SUBJECT: Forwards final response to NRC Questions 031.135, 031.137 & 031.138 re control sys failures, per SER Outstanding Issue 13. Responses will be incorporated into FSAR Amend 31.

Docket No. 50-397

Subject: NUCLEAR PROJECT NO. 2
CONTROL SYSTEM FAILURES QUESTIONS,
WNP-2 SER #3, OUTSTANDING ISSUE #13,
FINAL SUBMITTAL

FIGURE 1 - COLD SHUTDOWN PATHS - WPP-2

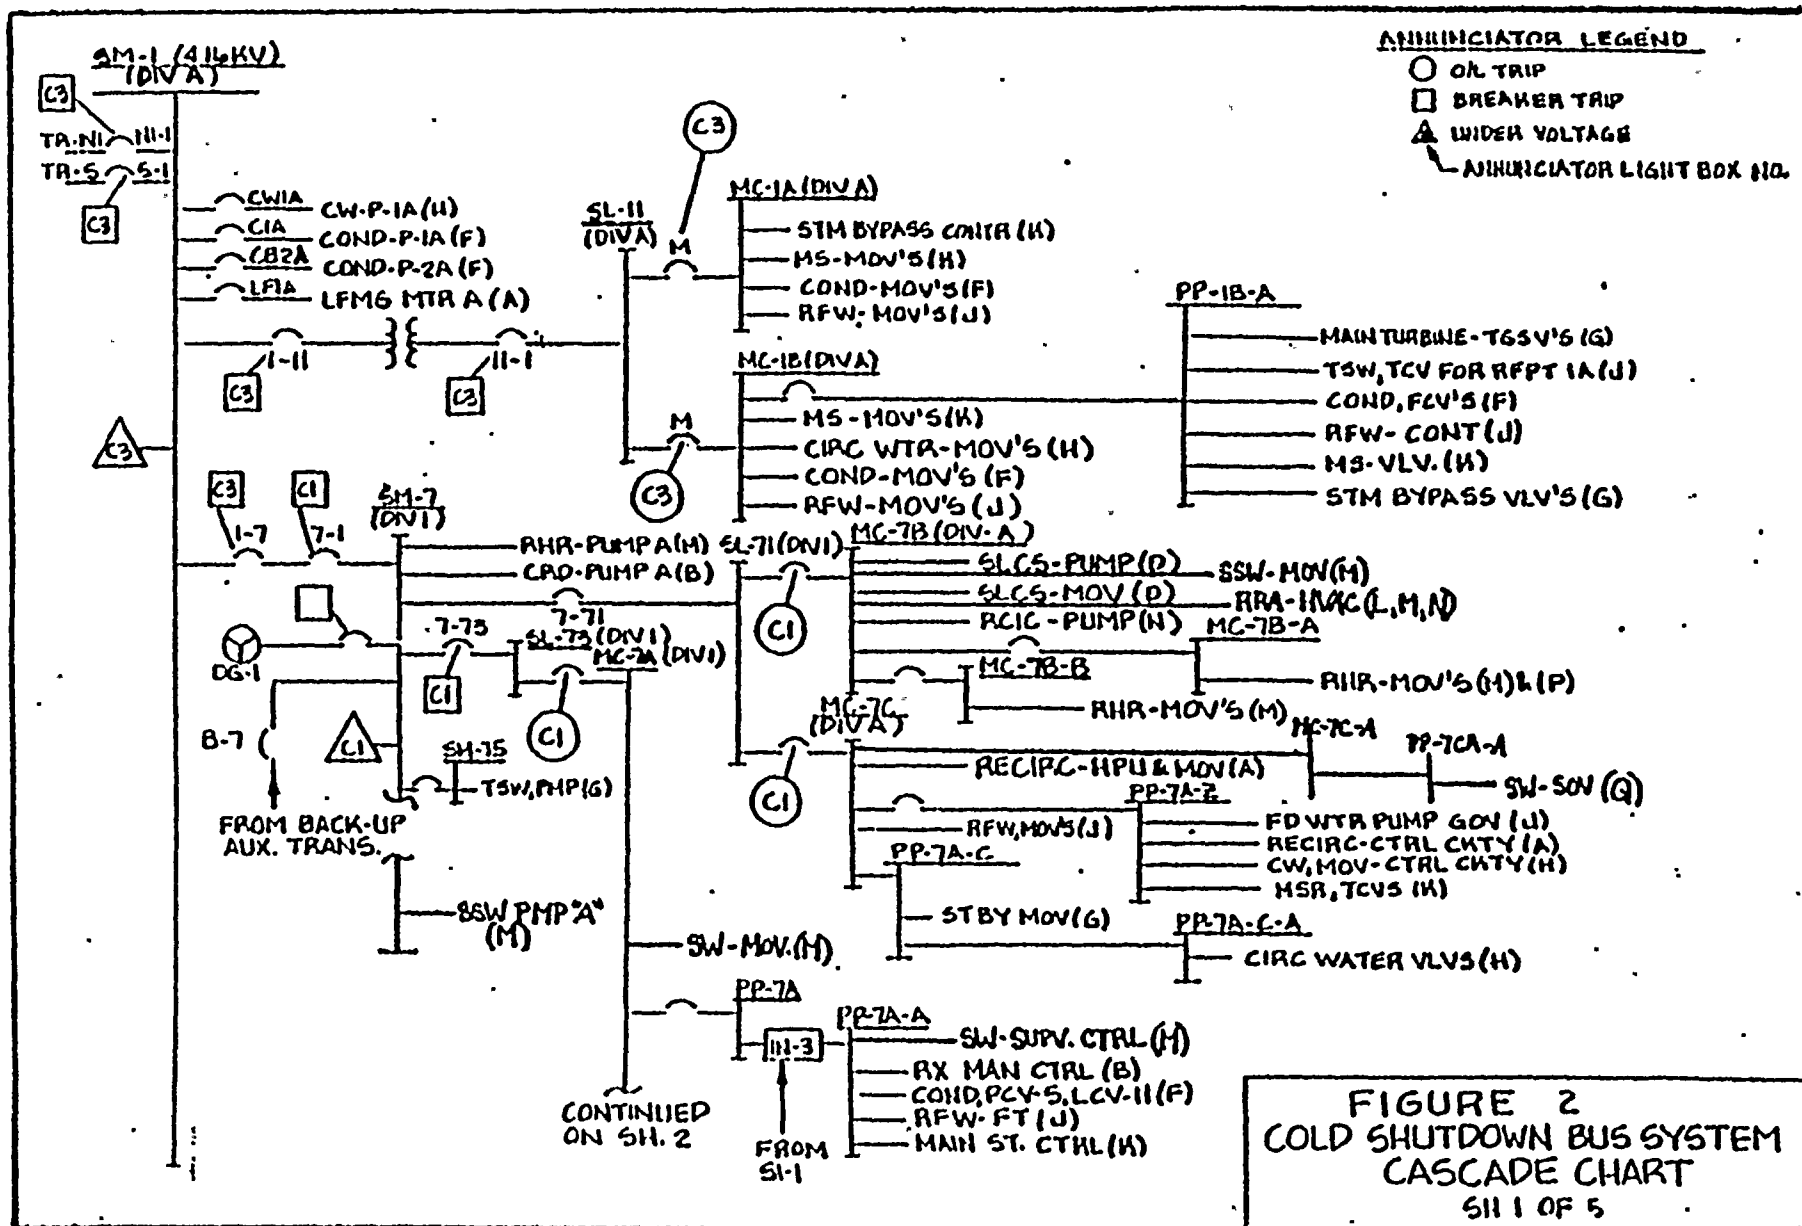
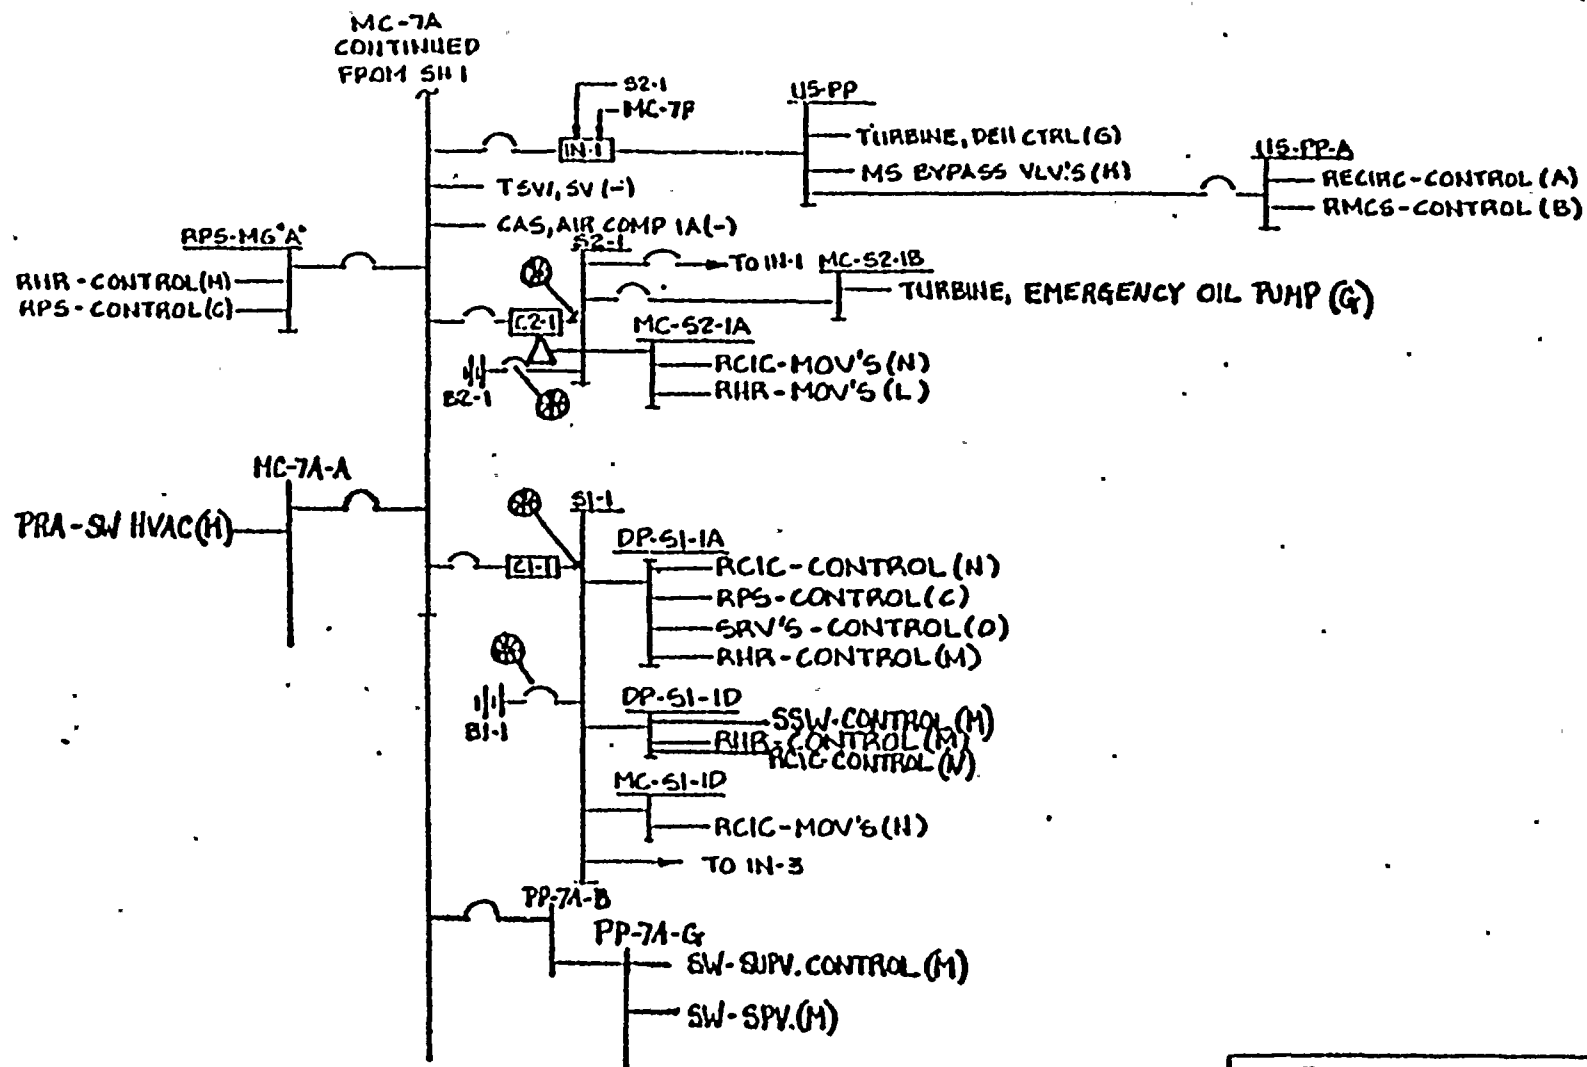
The shutdown paths are as identified in Figure 1. The information required to determine the three basic shutdown paths was obtained from plant procedures, P&ID's and WNP-2 FSAR system descriptions.

With reference to Figure 1, the alphabetical indicator, located in parenthesis in each system block, (e.g., (E); (F); etc.) represents the cross

FIGURE 2
COLD SHUTDOWN SYS
SH. 2 OF 5

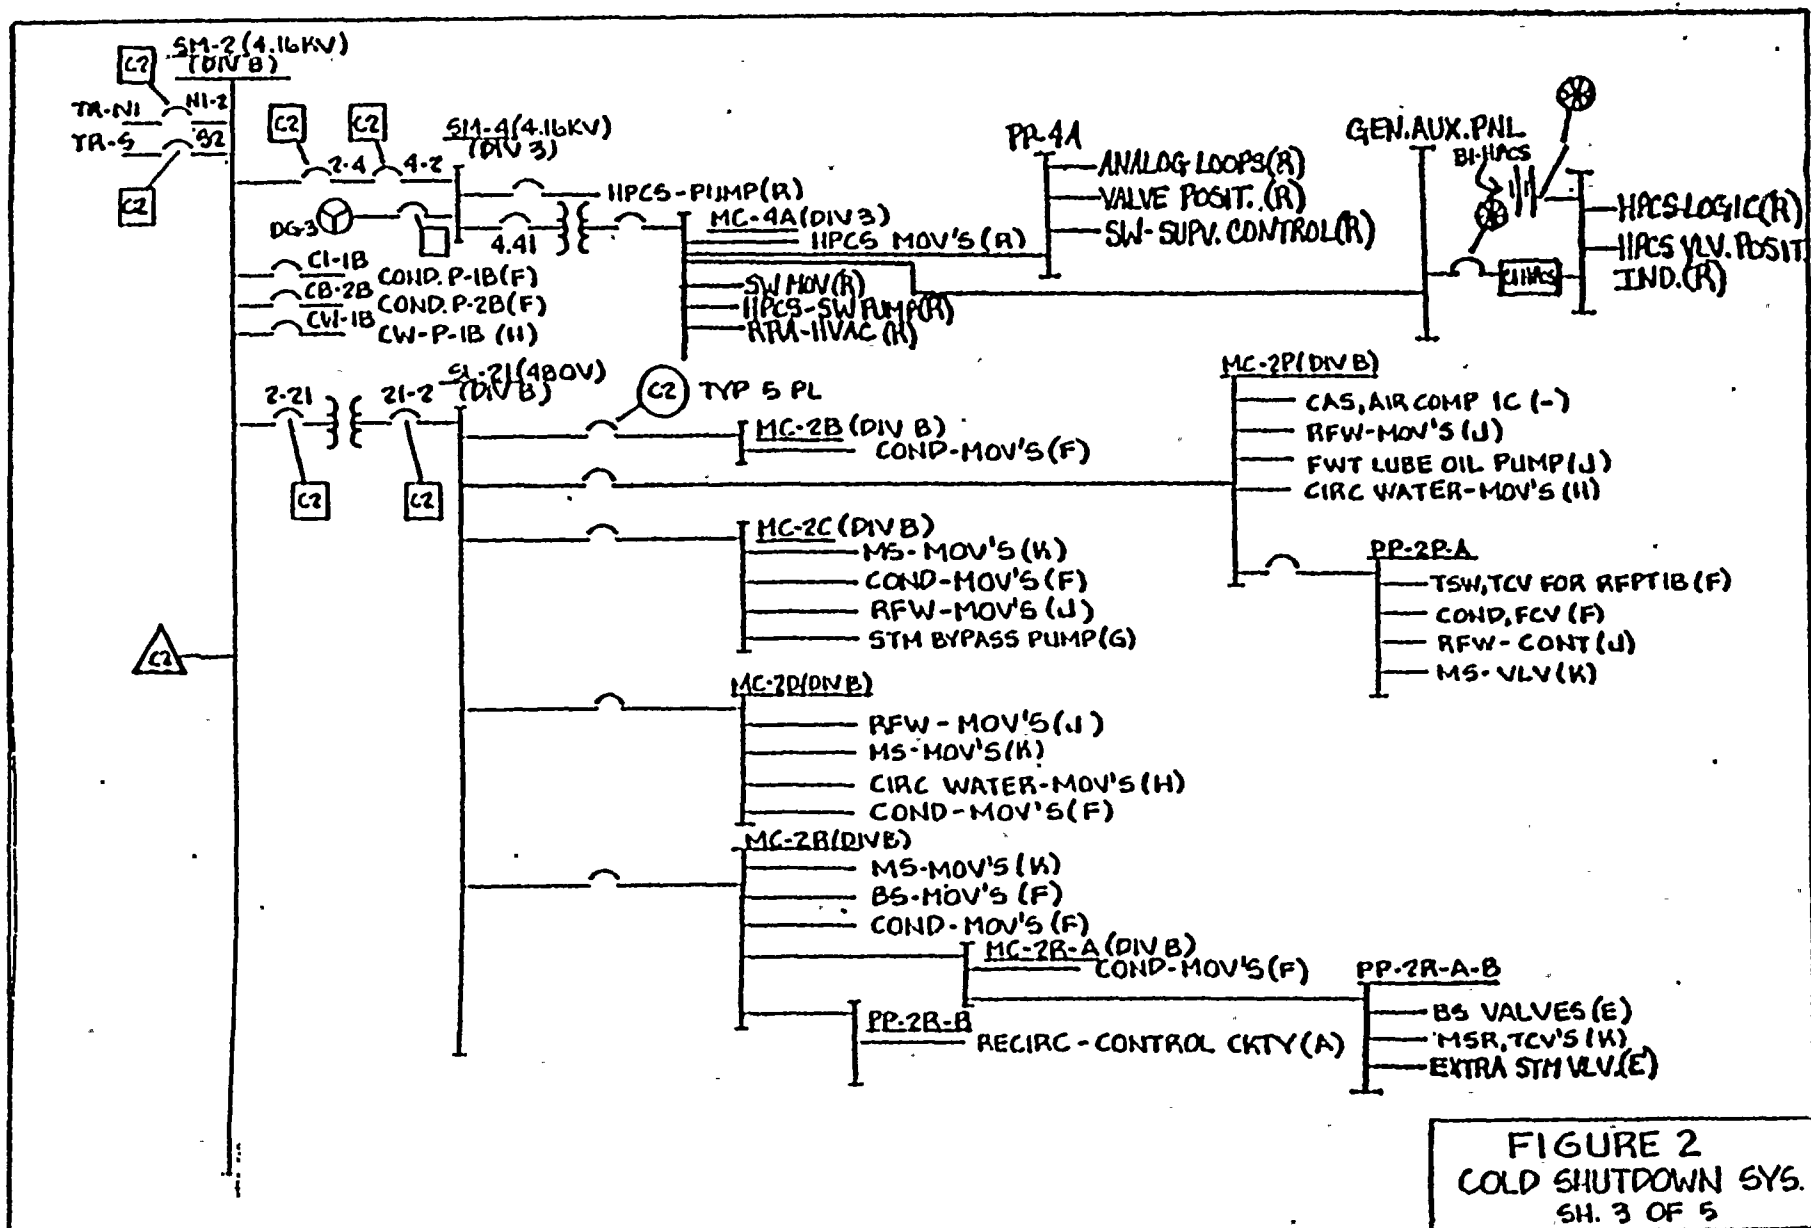
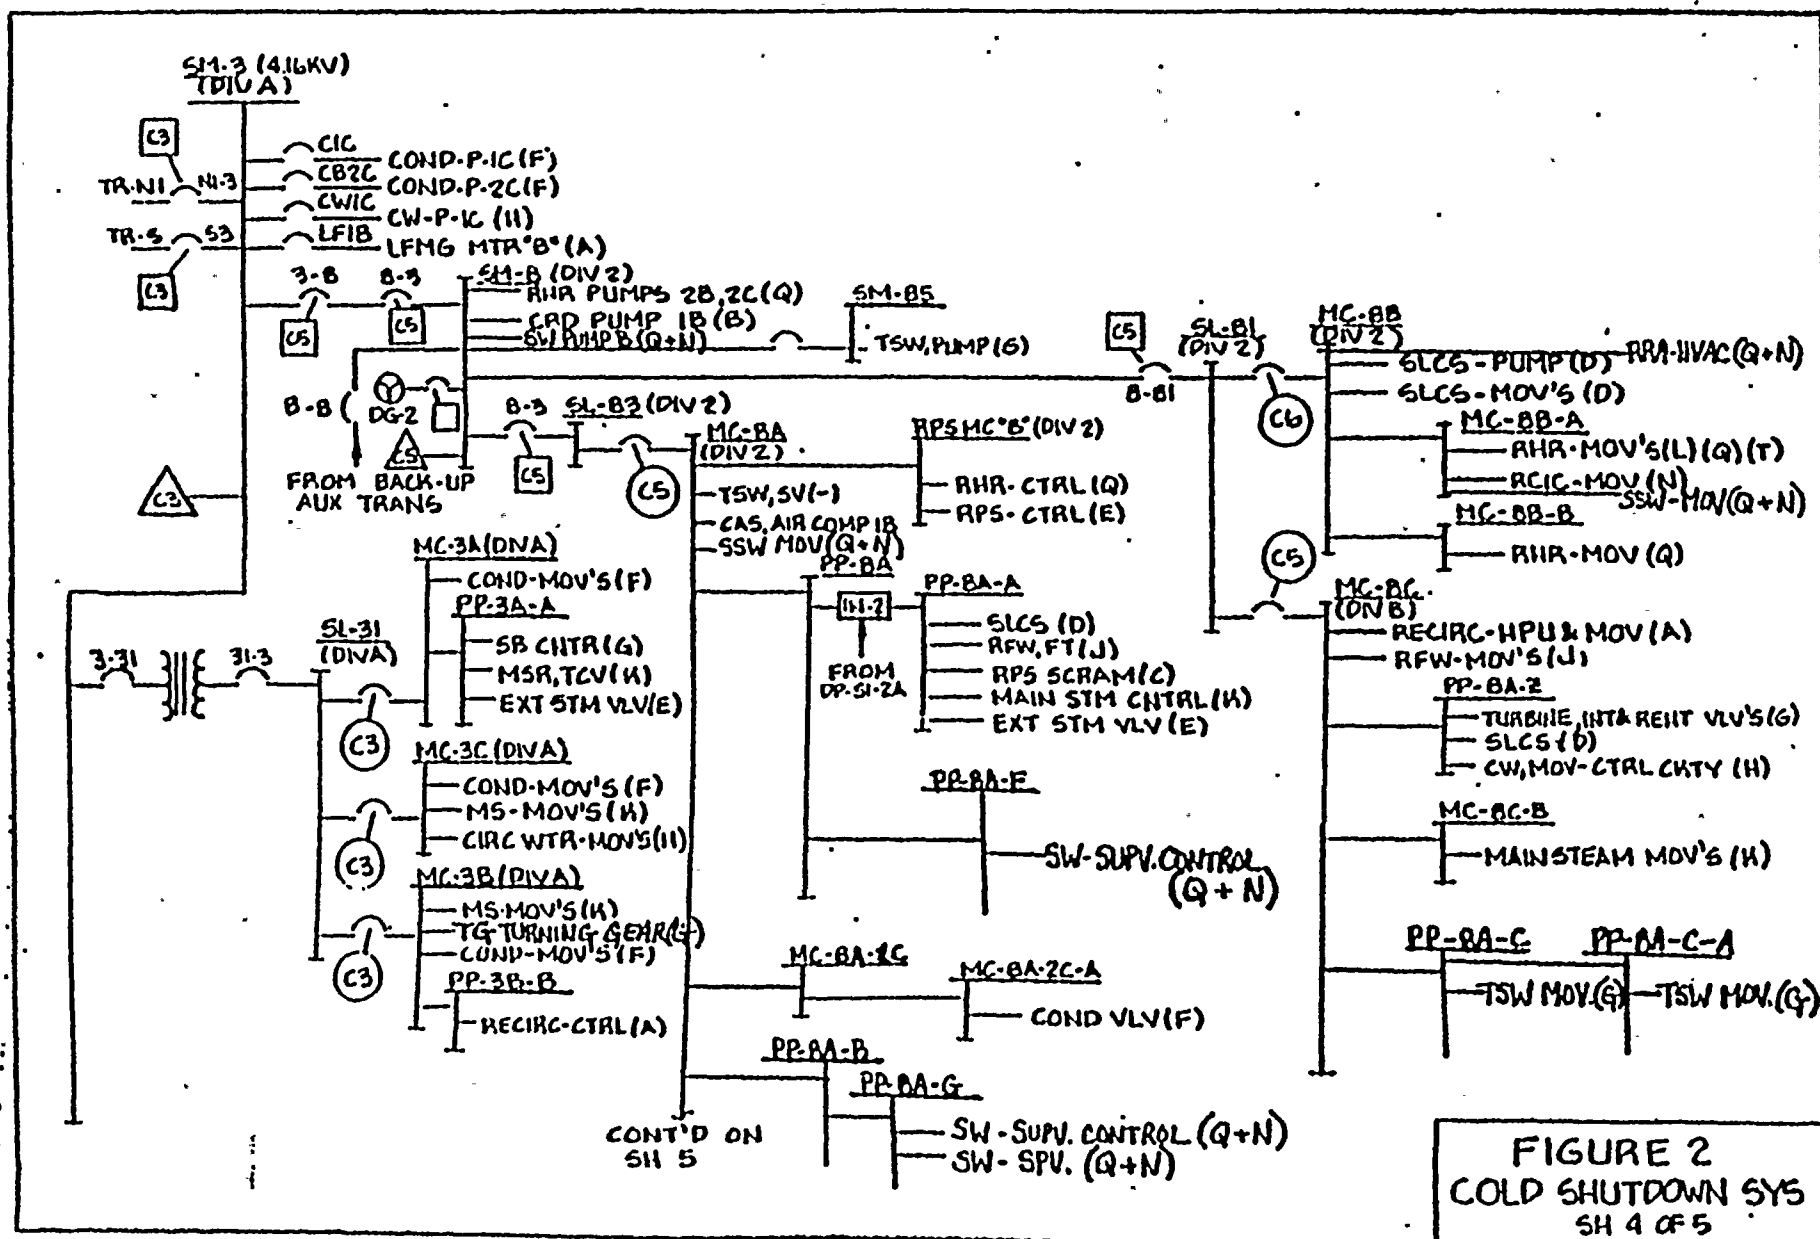
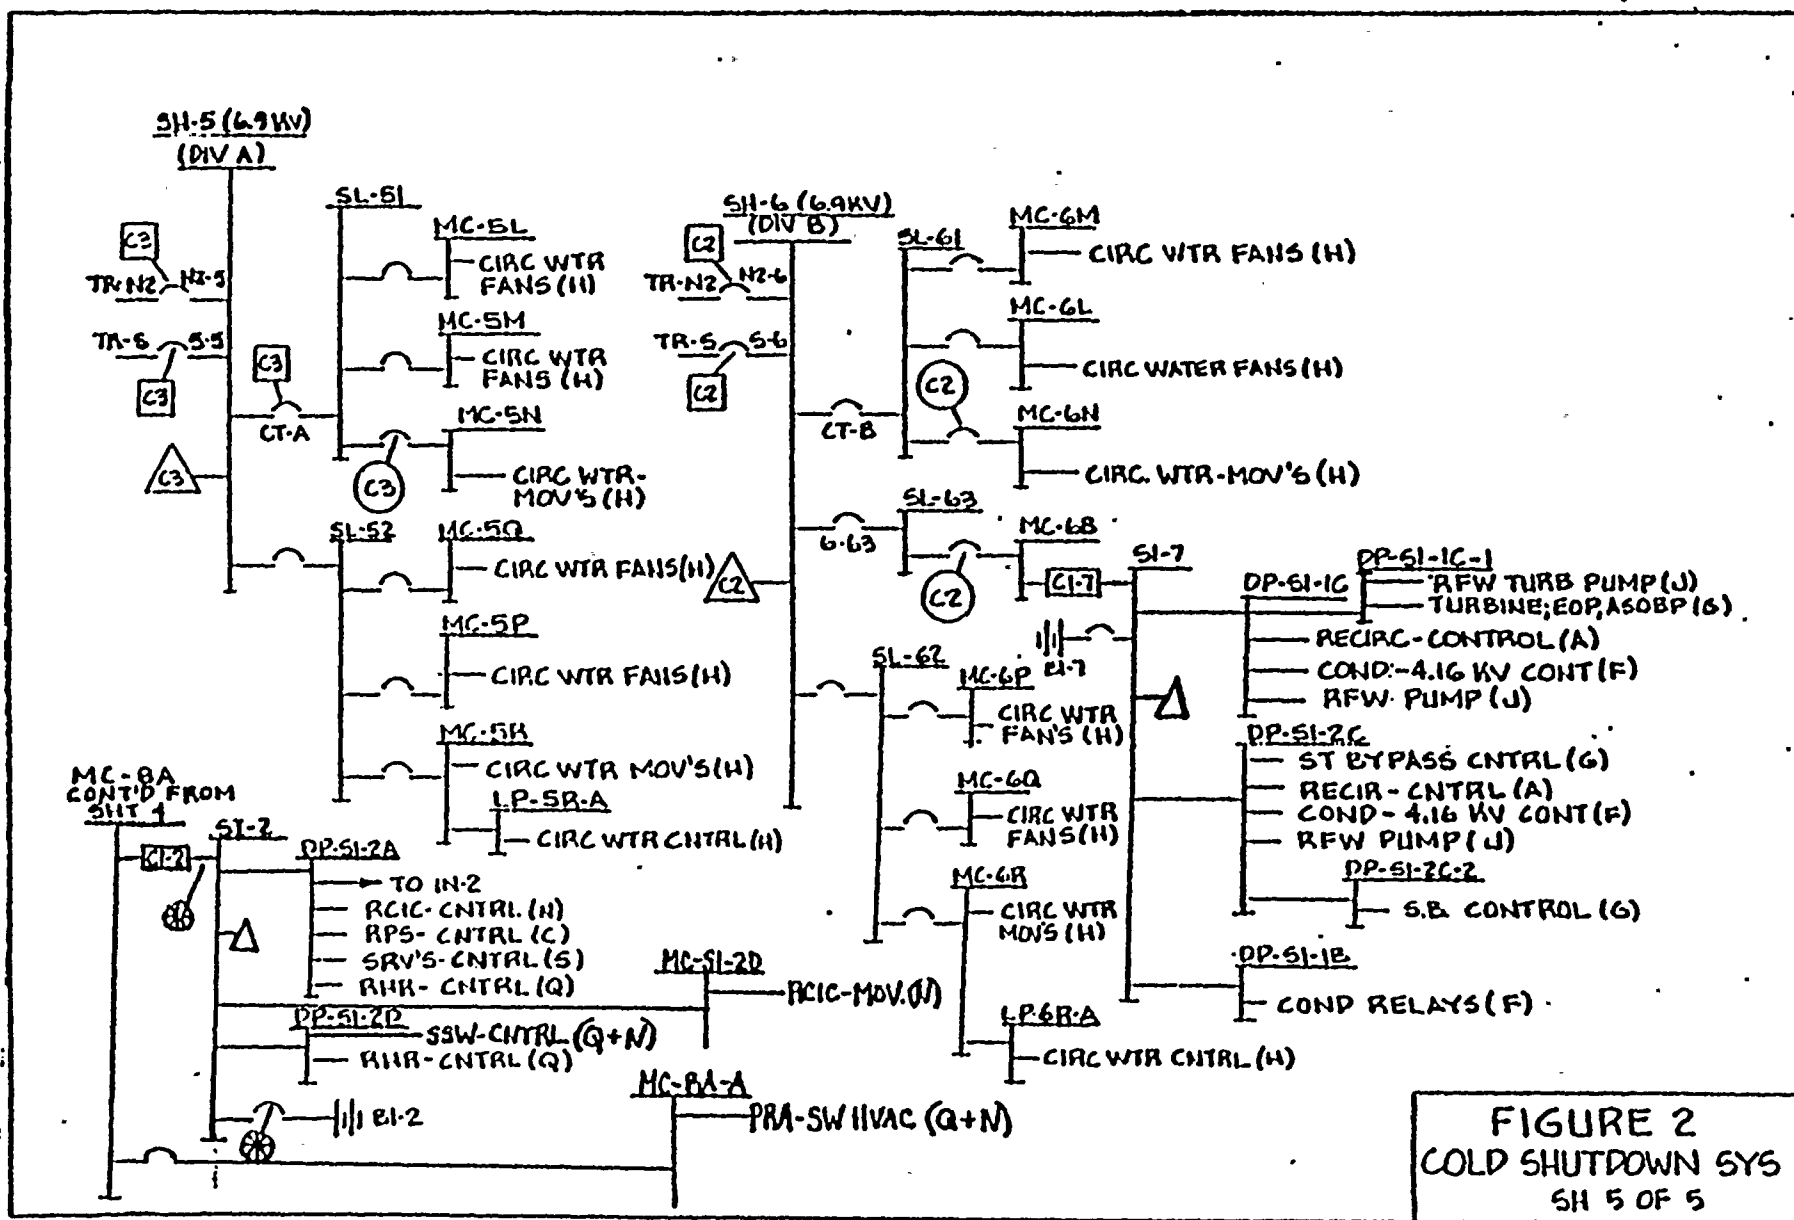
The identity of the alarm, indicator, or annunciator are shown in the appropriate column in Appendix A. Major bus annunciators are also identified on the "Bus system cascade chart" Figure 2.

Bus failure of a major bus (i.e., 6.9 kV thru 480 Volt) is annunciated in the control room, thus giving the operator the knowledge that bus power is lost. The review and analysis of Appendix "A" and Figure 2 shows conclusively that control room personnel will have knowledge of individual bus or circuit failures.
